SUBJECT: SUSQUEHANNA STEAM ELECTRIC STATION, UNITS 1 AND 2 – ISSUANCE OF AMENDMENT NOS. 283 AND 266 RE: CHANGE TO REACTOR STEAM DOME PRESSURE—LOW INSTRUMENT FUNCTION ALLOWABLE VALUE IN TECHNICAL SPECIFICATIONS (EPID L-2021-LLA-0184)

**SAFETY EVALUATION BY THE OFFICE OF NUCLEAR REACTOR REGULATION FOR
AMENDMENT NO. 283 TO RENEWED FACILITY OPERATING LICENSE NO. NPF-14
AMENDMENT NO. 266 TO RENEWED FACILITY OPERATING LICENSE NO. NPF-22
SUSQUEHANNA NUCLEAR, LLC
ALLEGHENY ELECTRIC COOPERATIVE, INC.
SUSQUEHANNA STEAM ELECTRIC STATION, UNITS 1 AND 2
DOCKET NOS. 50-387 AND 50-388**

**Analytical Limits, Nominal Trip Setpoints, and Allowable Values
for Functions 1.c, 1.d, 2.c, and 2.d in TS Table 3.3.5.1-1**

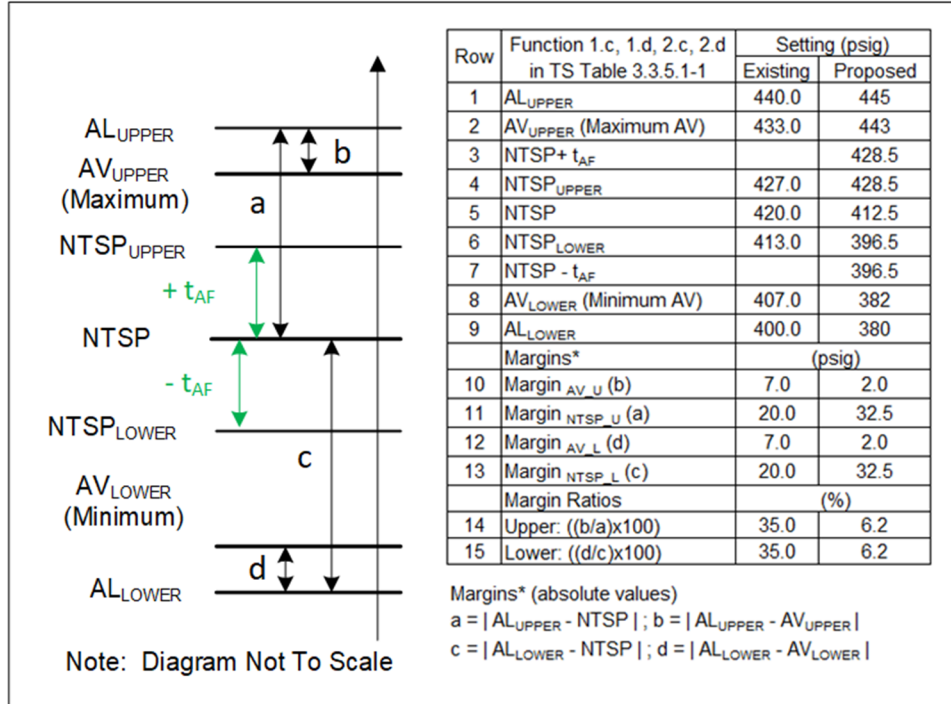
The NRC staff used the information in the LAR [1] and the supplements [2] [3] and followed the guidance in RG 1.105 [14] to independently calculate the margins and relationships among the ECCS instrumentation, analytical limits, nominal trip setpoints, and allowable values for functions 1.c, 1.d, 2.c, and 2.d in TS Table 3.3.5.1-1. The staff's independent confirmatory evaluation is summarized in the following figure. (The proposed setting values in this figure are for both units.)

Based on its review of the licensee's calculations and its independent confirmatory results in the figure above, the NRC staff have determined the following with respect to the proposed upper and lower allowable values:

- The licensee's equations from the excerpts of EC-080-1006 and EC-080-1007 [3] used to calculate the proposed allowable values, nominal trip setpoints, and drift allowances are consistent with GE NEDC-31336P-A [20] and RG 1.105 [14]. The licensee's calculations resulted in an as-found tolerance (t_{AF}) value of 16 psig. The NRC staff determined that this value is acceptable because it is the maximum allowed variation in the device setpoint that will remain within the range of acceptable setpoints.

- The NRC staff concludes that reasonable assurance that the trip signals from the ECCS circuitry will initiate before reactor steam dome pressure exceeds the upper and lower allowable values is provided because the value of the nominal trip setpoint plus the as-found tolerance (NTSP + t_{AF}) is less than the upper allowable value (AV_{UPPER}), and the value of the nominal trip setpoint minus the as-found tolerance (NTSP - t_{AF}) is greater than the lower allowable value (AV_{LOWER}). The staff also finds that the licensee determined the as-found tolerance values associated with the setpoint changes in a manner consistent with RIS 2006-17 [16]. The licensee periodically makes calibration adjustments as needed to ensure instrument calibration remains within a calibration tolerance band per plant technical specification surveillance requirements. The need for making calibration adjustments is determined by comparing as-found setpoint values with predetermined limits in accordance with RIS 2006-17 [16].

- The proposed changes result in a reduction of the margins between the proposed analytical limits and allowable values for both the upper and lower levels (Margin_{AV_U} and Margin_{AV_L} from rows 10 and 12 in the figure above) from 7 psig to 2 psig. This

corresponds in a decrease of the margin ratio for both upper and lower levels (rows 14 and 15 in the figure above) from 35 to 6.2 percent. However, the NRC staff's evaluation has confirmed that the licensee's uncertainty calculation results are adequately bounded by the requested allowable values. Therefore, the staff finds the proposed allowable value settings continue to assure that a trip or safety actuation will occur well before the measured process reaches the analytical limits. The staff also finds that the proposed allowable value settings will continue to support an automatic protective action before a safety limit is exceeded because the licensee has established adequate margins between the allowable values and the analytical limits.

Based on the above evaluation, the NRC staff finds that the licensee's methodology, analysis, assumptions used for this application, and the proposed changes maintain adequate allowable values based on the margins to analytical limits established that are consistent with RG 1.105 [14]. The proposed changes provide the ability to monitor variables over their anticipated ranges for both normal and accident conditions to assure adequate safety and integrity of the reactor core, and the reactor coolant pressure boundary because of the acceptable allowable values established and surveillance testing that will be performed to ensure continued instrument operability; therefore, the proposed changes satisfy the requirements of GDC 13. The NRC staff further finds that the requirements of 10 CFR 50.36(c)(1)(ii)(A) and 10 CFR 50.36(c)(3) will continue to be met because the automatic protective action will continue to support automatic protective actions before the established safety limits are exceeded.
